ADDENDUM NO. 2

PROJECT TITLE: REPLACEMENT OF MNRR BRIDGE OVER ATLANTIC STREET - PHASE 1 I-95 NB EXIT 8 RAMP BRIDGE

DRAWING TITLE: RETAINING WALL 102 GENERAL PLAN - 1

PROJECT NO. 135-326
DRAWING NO. RW-01
SHEET NO. 07.001.A2

GENERAL PLAN

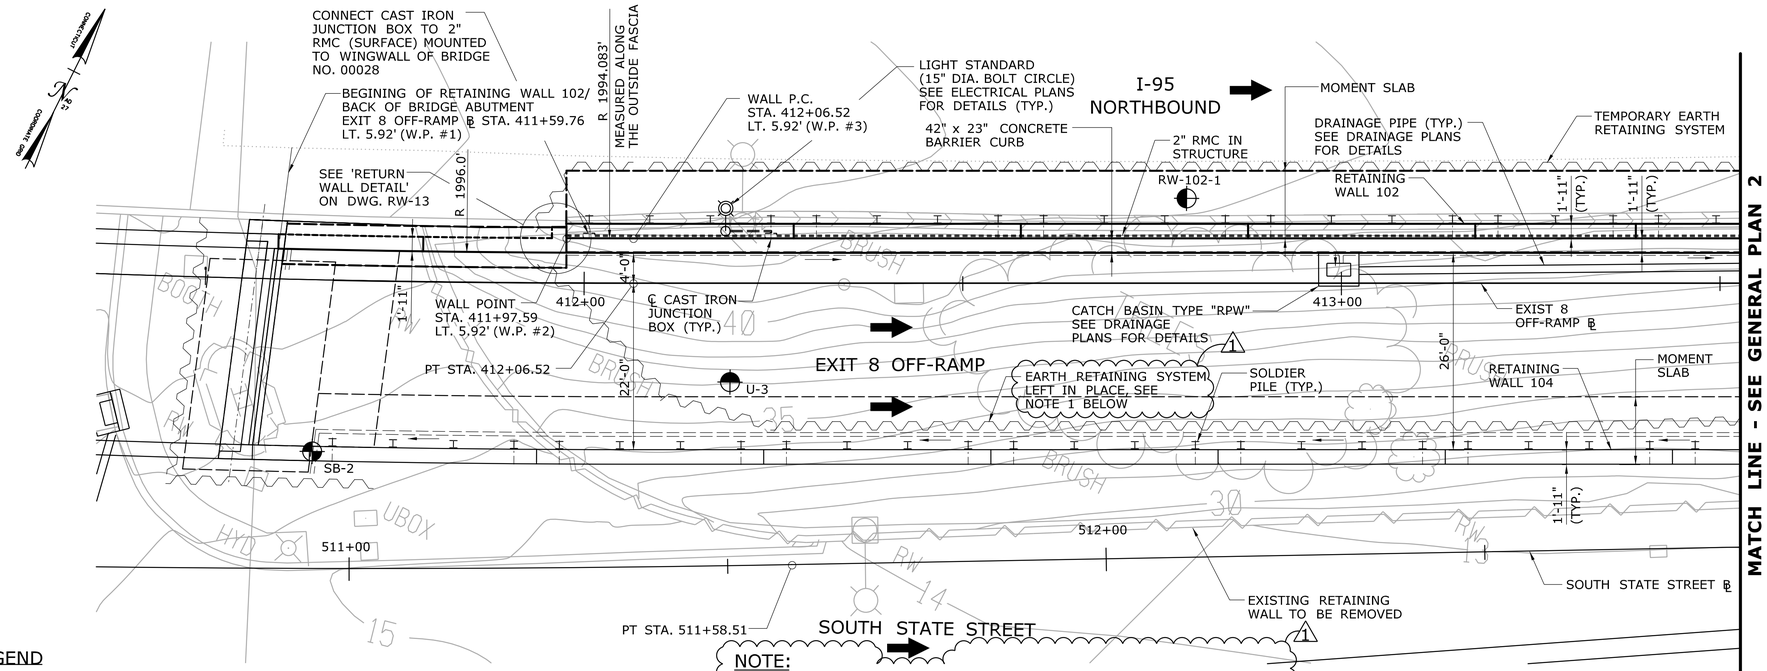
1. THE COST OF TEMPORARY EARTH RETAINING SYSTEM OR EARTH RETAINING SYSTEM LEFT IN PLACE SHALL BE INCLUDED IN THE LUMP SUM COST OF THE ITEM "REMOVAL OF EXISTING RETAINING WALL (SITE NO. 1)".

GENERAL PLAN

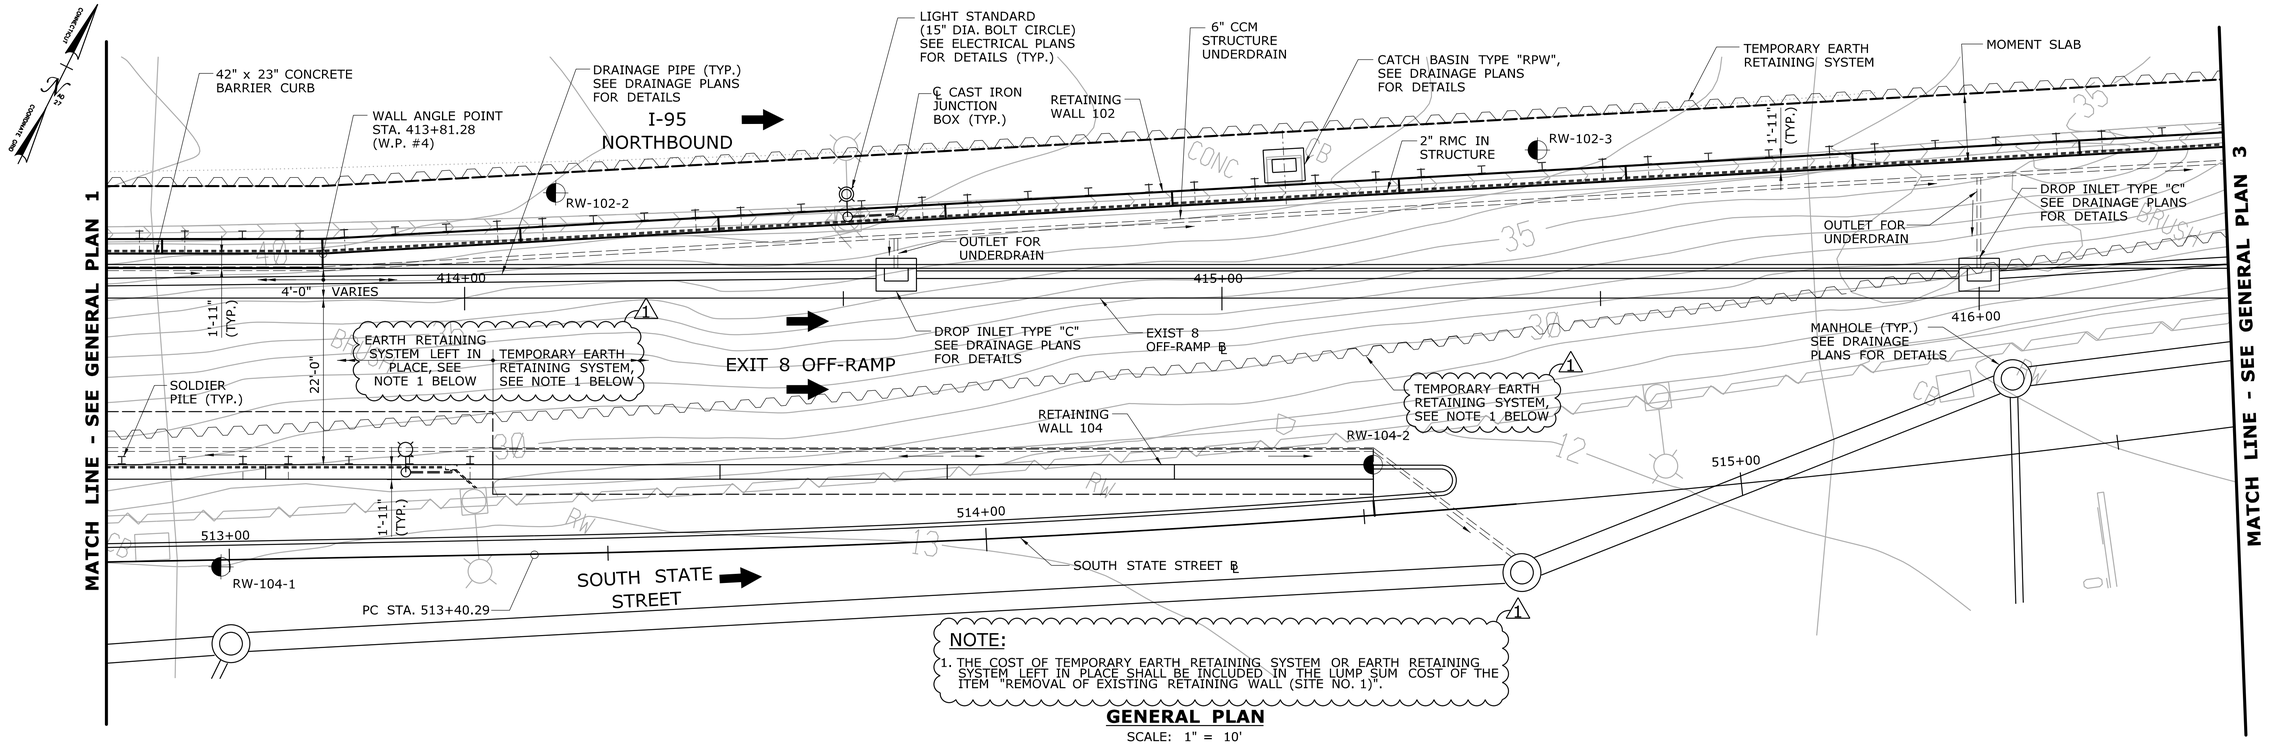
1. THE COST OF TEMPORARY EARTH RETAINING SYSTEM OR EARTH RETAINING SYSTEM LEFT IN PLACE SHALL BE INCLUDED IN THE LUMP SUM COST OF THE ITEM "REMOVAL OF EXISTING RETAINING WALL (SITE NO. 1)".
